SECY-92-378

Subject: FIRE ENDURANCE TESTING ACCEPTANCE CRITERIA FOR COMANCHE PEAK  
STEAM ELECTRIC STATION UNIT 2

SUBJECT: THERMO-LAG ACCEPTANCE METHODOLOGY FOR COMANCHE PEAK STEAM  
ELECTRIC STATION - UNIT 2

Test Sequence

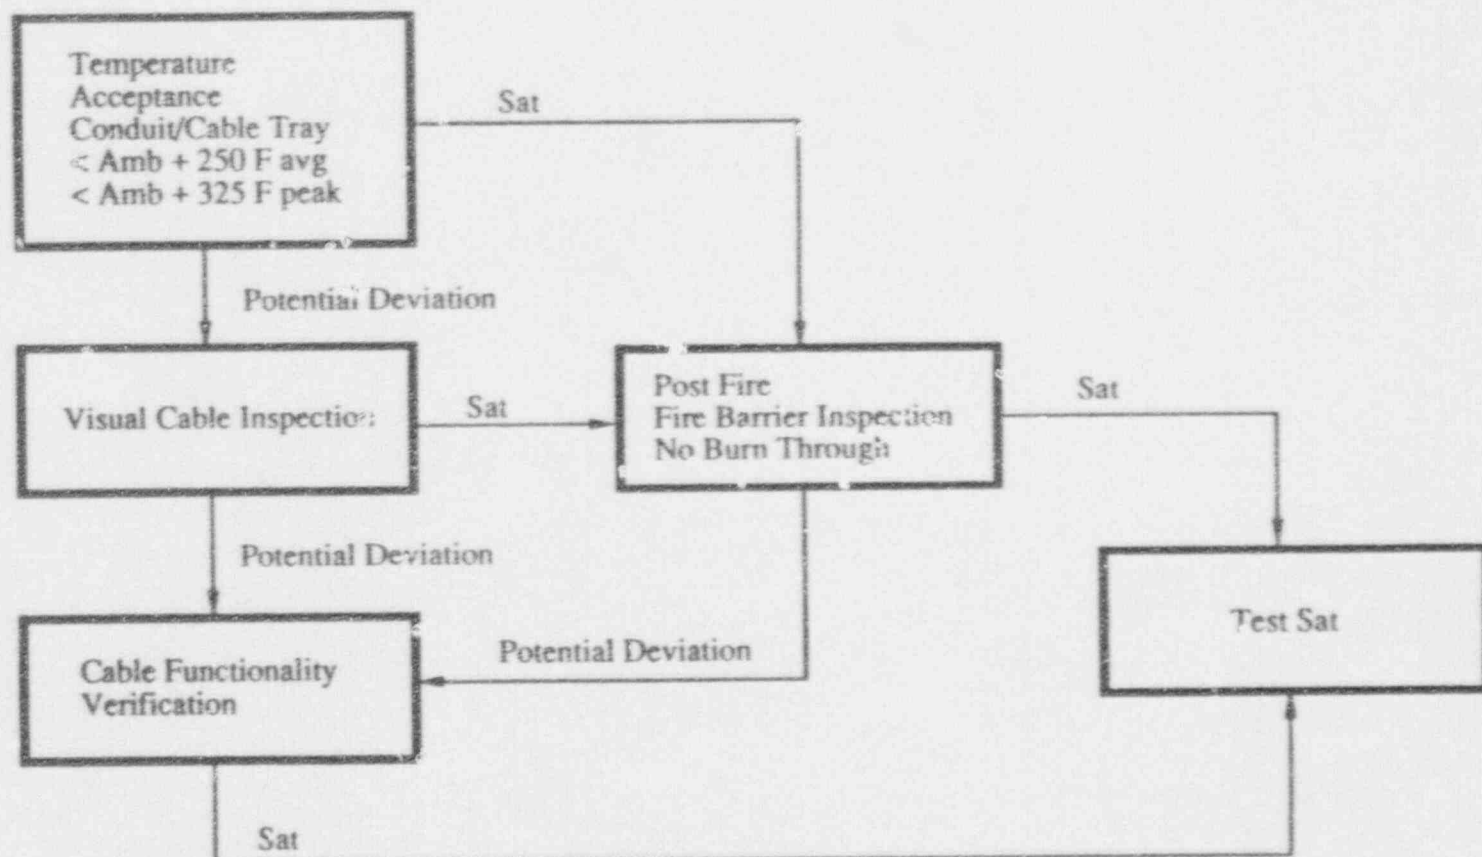
4. Your acceptance methodology calls for a megger test after the cable has been installed in the raceway, continuity measurements during the test, and a subsequent megger test immediately following the test. At the October 27, 1992 meeting, you provided additional details and clarification regarding your proposed testing to demonstrate cable functionality. Additionally, you stated that you may use loss-of-coolant-accident (LOCA) cable qualification test results in evaluating cable functionality at elevated temperatures.

At the October 27, 1992 meeting, the NRC staff described the following tests which can be used to demonstrate functional performance of cables where there are signs of thermal damage to cables or where barrier burnthrough or openings occur:

The NRC concludes that performance of your proposed testing, with the additional megger and Hi-Pot testing described above, would constitute an acceptable set of tests to demonstrate that any fire barrier test deviations, should they occur, will not affect the capability of the protected cable to perform its safety function. Other tests or combination of tests for cable functionality, different from those described above, would require NRC review and approval.
